## SONARtrac® Rework Instruction

CIDRA Subject: Rework Fender **Assembly Gasket Material**

RI00011 Rev: 01 Page 1 of 2

**Description:** This procedure describes the replacement of the fender gasket material with a silicon foam rubber gasket material (CiDRA P/N 52305-04) adhered to the fender with RTV adhesive (CiDRA P/N 52118-01). The gasket material called out in Table 1 (Gasket Kit length by Pipe Diameter) is for (1) fender section, (4) fender sections are used per cover. One tube of RTV will be supplied for up to (4) fender sections.

Figure 1 Fender Rework

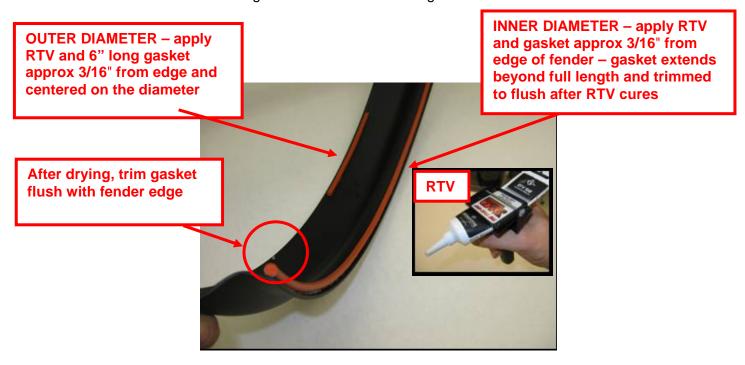
- 1. If necessary, remove existing Gasket material from the Fender. Ensure surface is clean.
- 2. Cut piece of gasket material to just beyond the inner diameter length.
- 3. Apply 1/8" bead of RTV 108 onto entire length of INNER DIAMETER. Apply bead approximately 3/16" from edge.
- 4. Install the Gasket onto the RTV. Leave extra length on both ends, ends will be trimmed later.
- 5. Cut a piece of Gasket material approx. 6" long.
- 6. Apply 1/8" bead of RTV 108 approx. 6" long centered on the OUTER DIAMETER. Apply bead approx. 3/16" from edge.
- 7. Install 6" long gasket onto the RTV.
- 8. Allow to dry for 12 hrs.
- 9. Cut INNER DIAMETER gasket flush with fender edge.
